Subject: Clinton Power Station Unit 1
Humphrey Concerns

Reference: IP letter U-0596 dated 2/4/83, G. E. Wuller to
A. Schwencer, NRC, subject: Submittal addressing
some John Humphrey concerns.

The referenced letter addressed some of the John Humphrey concerns as applicable to the Clinton Power Station (CPS). Enclosed are CPS responses on some additional Humphrey issues for NRC Staff review. Included are Action Plans #15, 18, 19, 22, 25, 28, 31 and 32. We believe that these responses will resolve the particular concern involved.

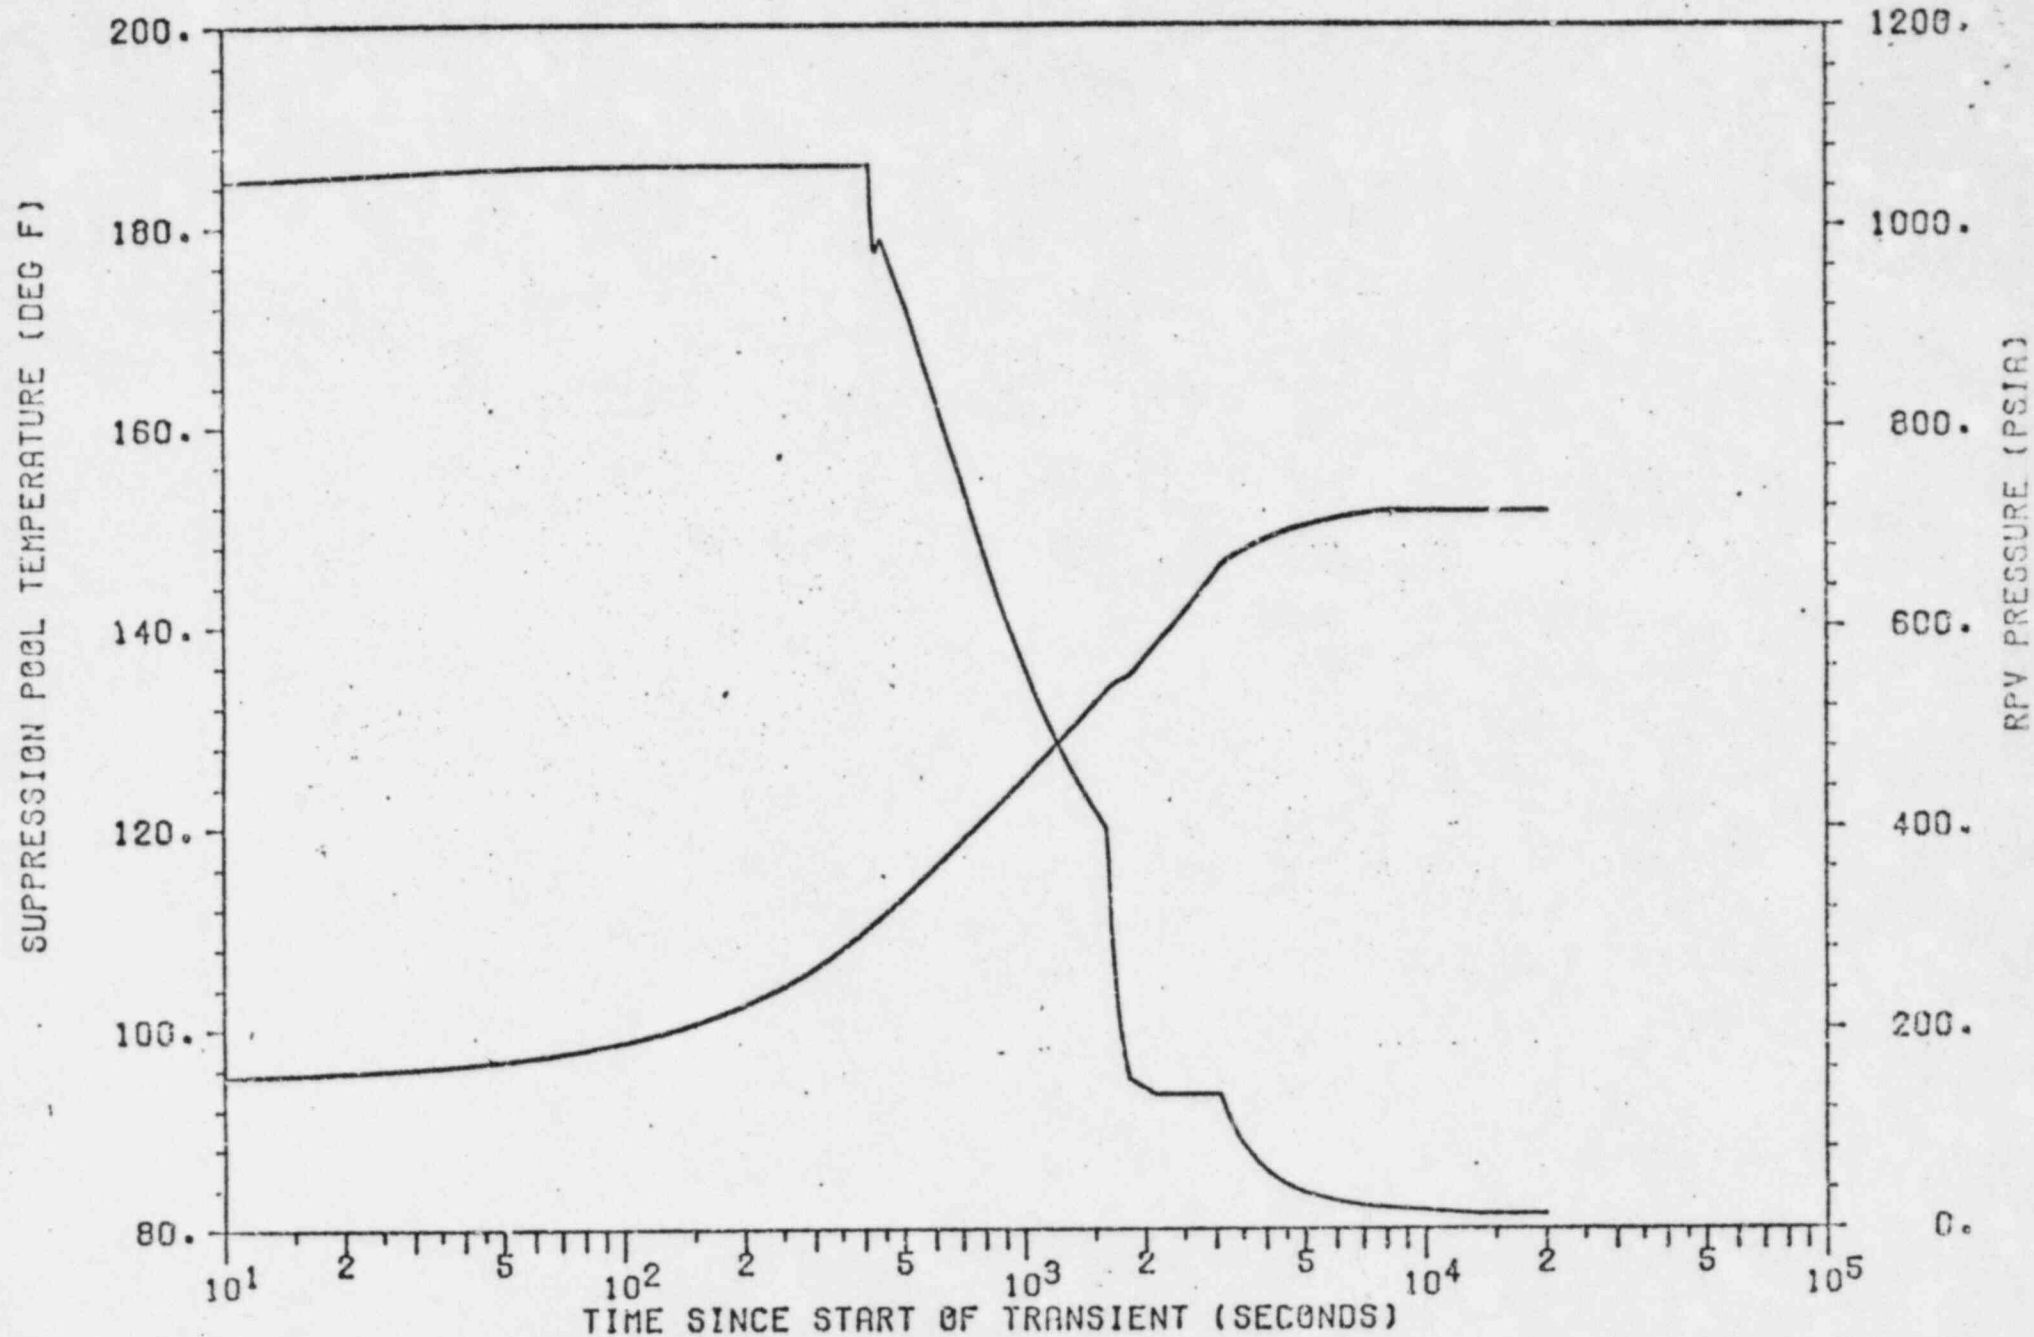
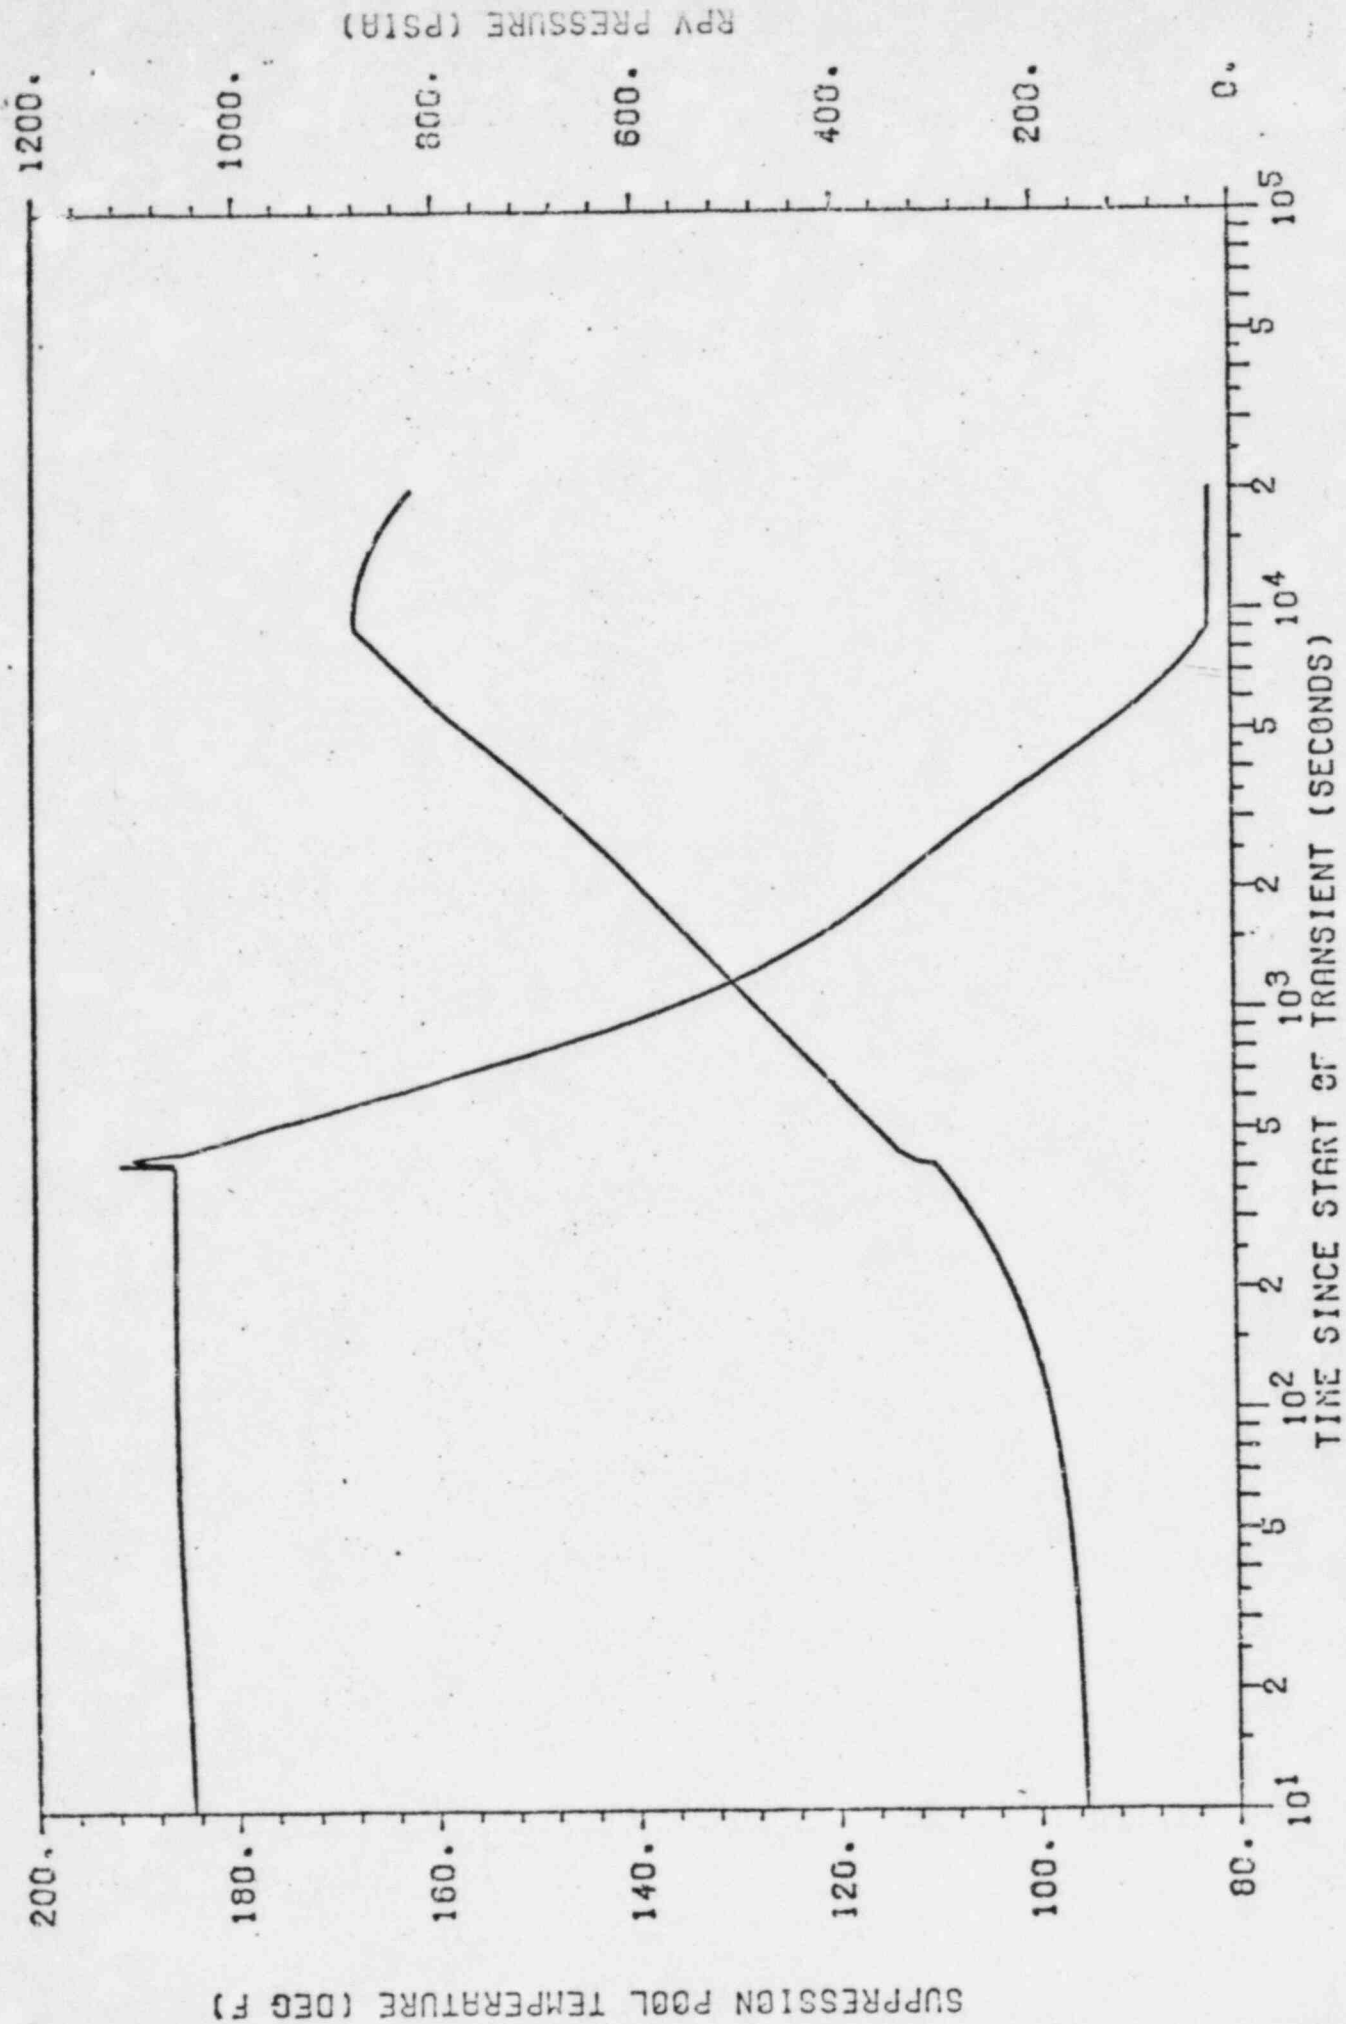
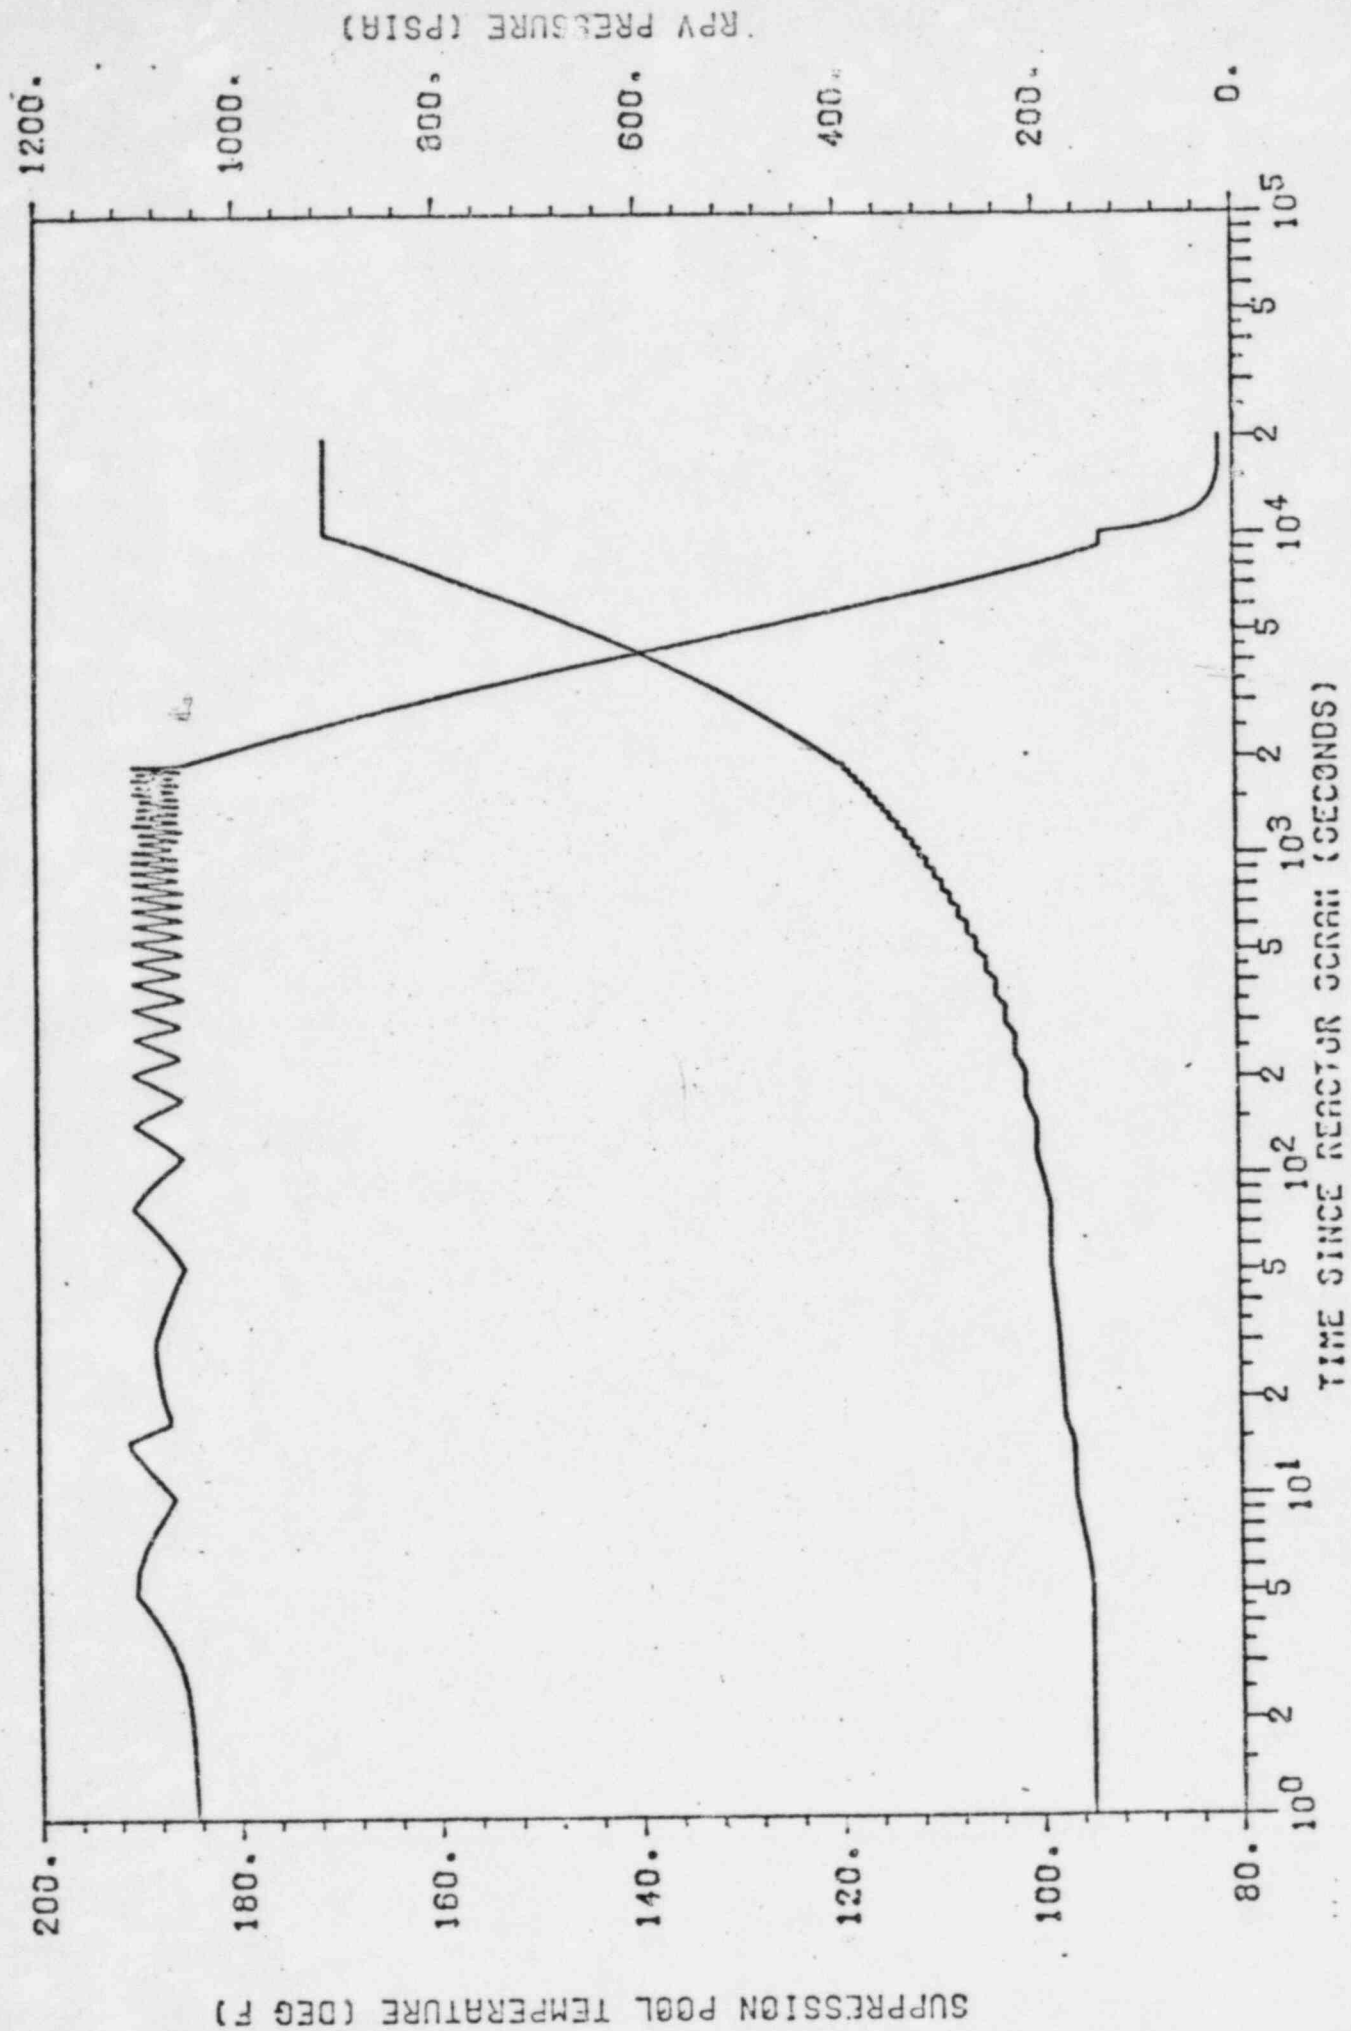
- 9.3 It appears that some confusion exists as to whether SBA's and stuck open SRV accidents are treated as transients or design basis accidents. Clarify how they are treated and indicate whether the initial conditions were set at nominal or licensing values.
- 9.4 The design basis calculations for stuck open relief valves should not rely on a manually initiated scram to occur within a short time interval of the SRV occurrence. The analysis should assume that scram is initiated when the pool temperature reaches 110°F or 10 minutes after occurrence of the SORV.

The stuck open relief valve transients and small break accident transients in the suppression pool have been evaluated (see attachment I). The results of this evaluation shows that the maximum suppression pool temperature expected is 171°F. This is less than the design temperature of 185°F.

The six identified transients are: (1) Stuck open relief valve (SORV) at full power with a loss of 1 residual heat removal (RHR) heat exchanger and with the condenser available to an RPV pressure of 150 psia; (2) SORV at full power with spurious isolation; (3) Isolation scram with 1 RHR heat exchanger available; (4) Isolation scram with SORV and loss of shutdown cooling; (5) Small break accident (SBA) with a loss of 1 RHR heat exchanger; and, (6) Small break accident (SBA) with loss of shutdown cooling. A detailed description of assumptions relevant to each of the cases is presented in Table 28.1 and 28.2. Table 28.3 presents the Clinton specific data that were used in these evaluations. Pertinent parameters related to the SRV's are presented in Table 28.4. The assumed system delay times are summarized in Table 28.5. The event sequence for each analysis is given in Table 28.6. Final results are shown in Table 28.7.
